# **Appendix B4**

# **Meadowbank Dike Review Board Reports**

Report No 17 Meadowbank Mine Dike Review Board Meeting July 27-30, 2015

SUBJECT: RESPONSE TO REPORT No.17, MEADOWBANK DIKE REVIEW BOARD

Photo #5 Central Dike, bedding and transition zones that confine the soapstone fill

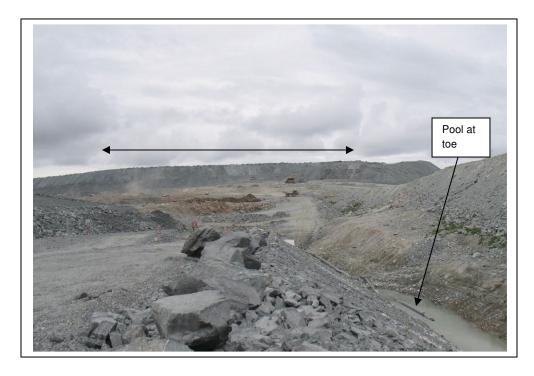
The Board made note of the behaviour of the Non Potentially Acid Generating (NPAG) soapstone rockfill being placed in the Central Dike embankment (Photo #4). While the interest in using this material is understood due to the overall shortage of NPAG material there are limitations as to what can be done with the ultramafic soapstone. A high degree of crushing and/or grinding when exposed to vehicular traffic is evident. The GAL recommendation to place and compact the material in 1 m lifts rather than 2 m may not be appropriate, particularly if the
